Amendment No. 6 (Technical)

Tender Package Name: “Design, Manufacturing, Supply, Erection, Testing & Commissioning of 160 MVA, 220/33-33 kV Gas Insulated Substation (GIS) at Lassipora on Turnkey Basis associated with Strengthening of Transmission System of JKPDD under PMDP Scheme-15

Tender Specification No- RECTPCL/PIA/JKPDD/SS- 02 Dated: 18-11-2017

CONNECTION ARRANGEMENT OF SINGLE PHASE TRANSFORMERS UNIT, NEUTRAL FORMATION & SPARE UNIT CONNECTION BY AUXILIARY BUS(GIS)

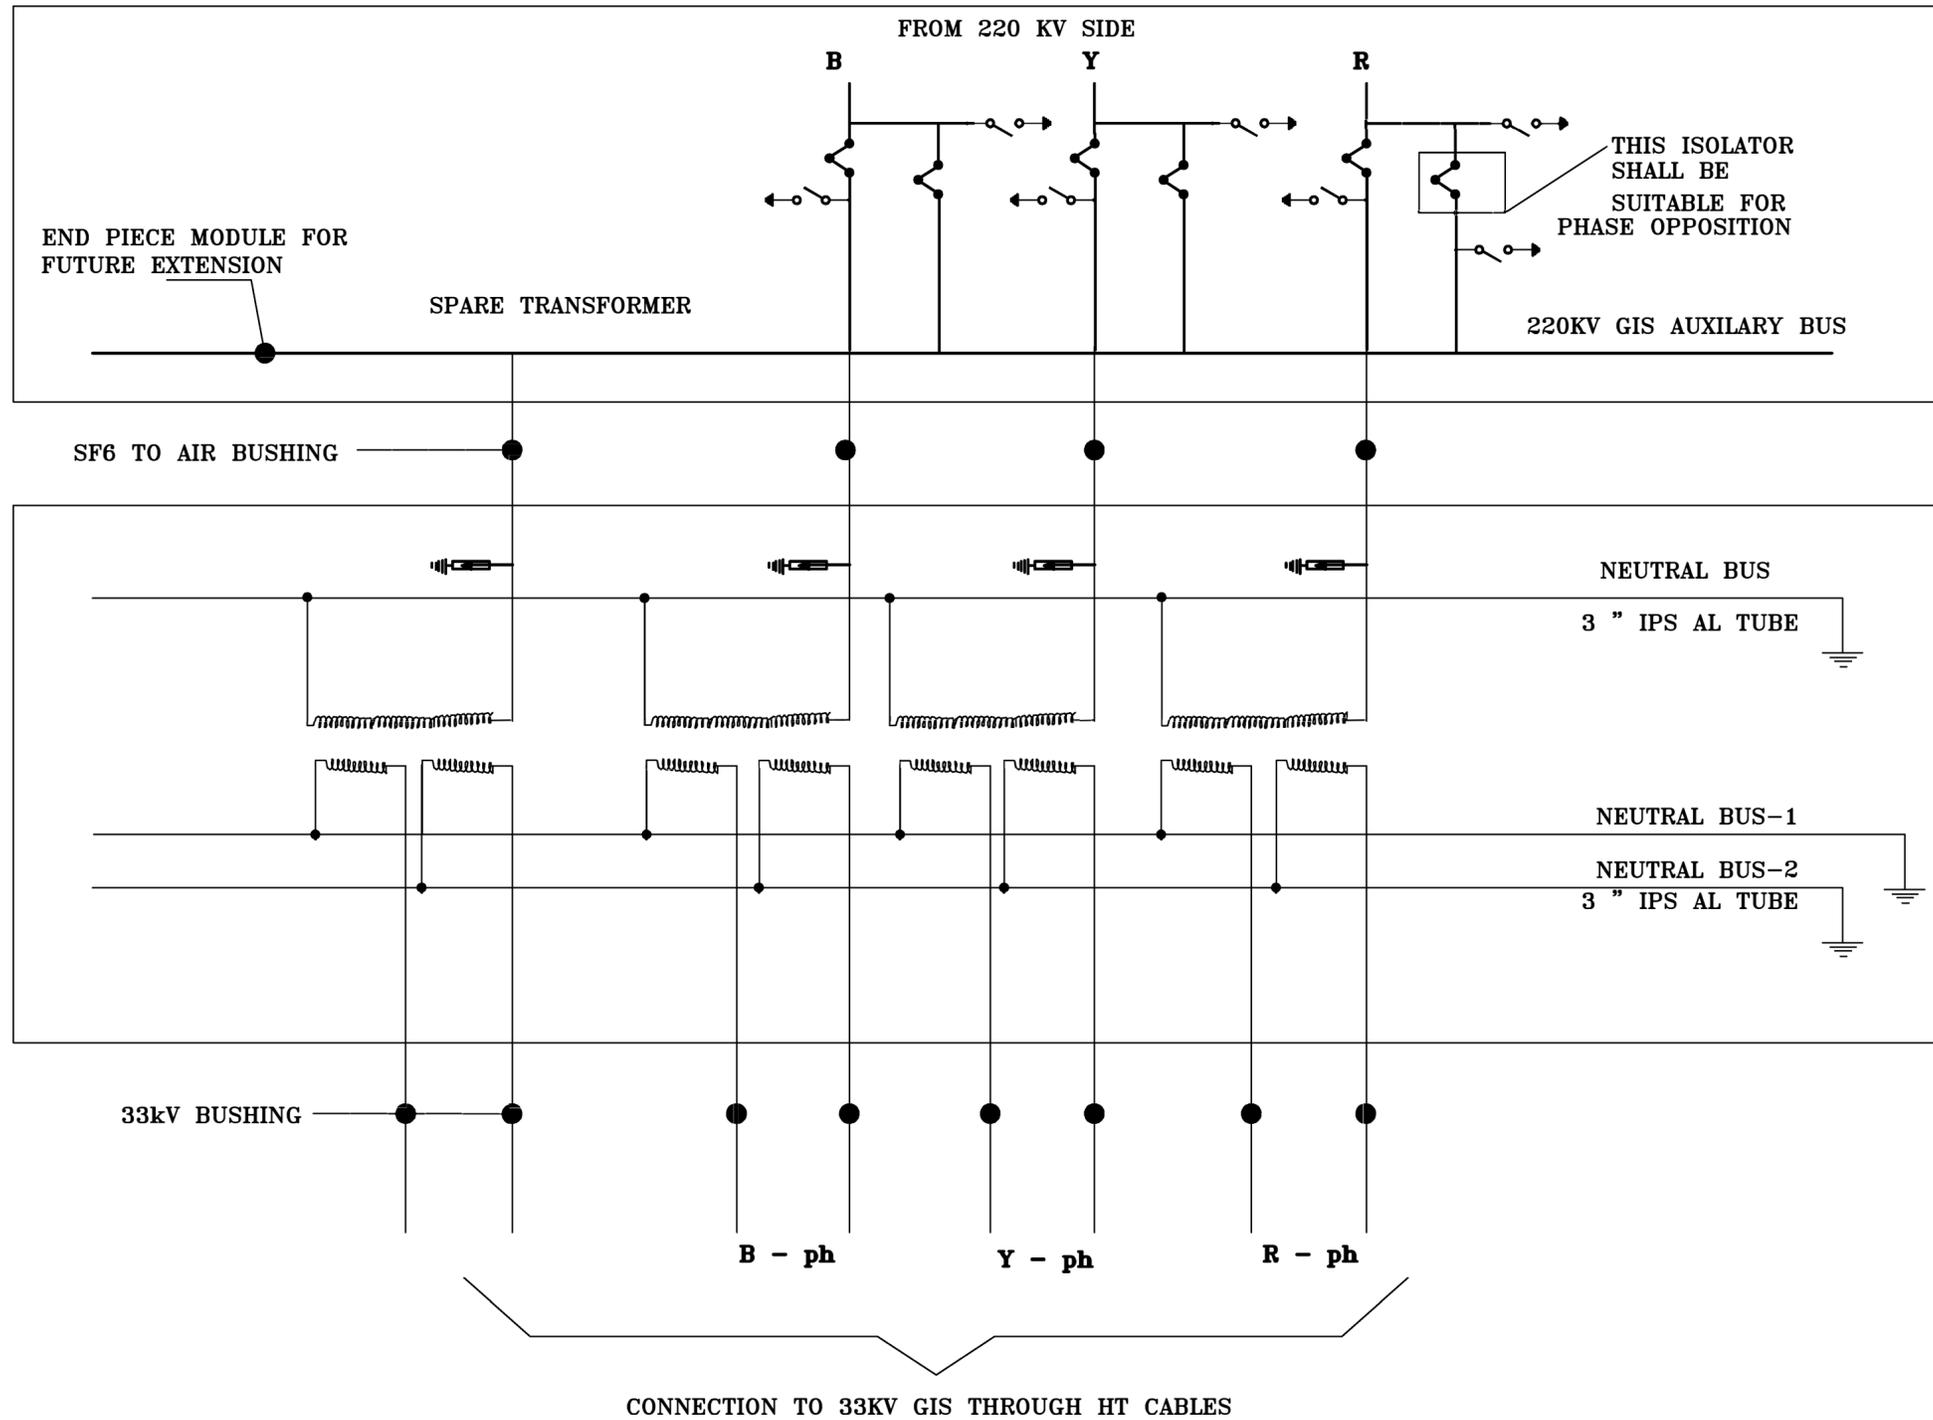
S. No.	Clause No.	Existing Clause	To be Read as
A. SECTION-I, Project, VOL-II			
1	Connection Arrangement of Single Phase Transformer Unit, Neutral Formation & Spare Unit Connection by Auxiliary Bus (GIS) under Revised Annexure-II of Section-I, Project	No such Drawing	Drawing for connection arrangement of single phase transformer unit, neutral formation & spare unit connection by auxiliary bus (GIS) with Drawing Sl No- RECTPCL/J&K/DRG/23 is annexed at Annexure-1 to Amendment-6 (Technical) .
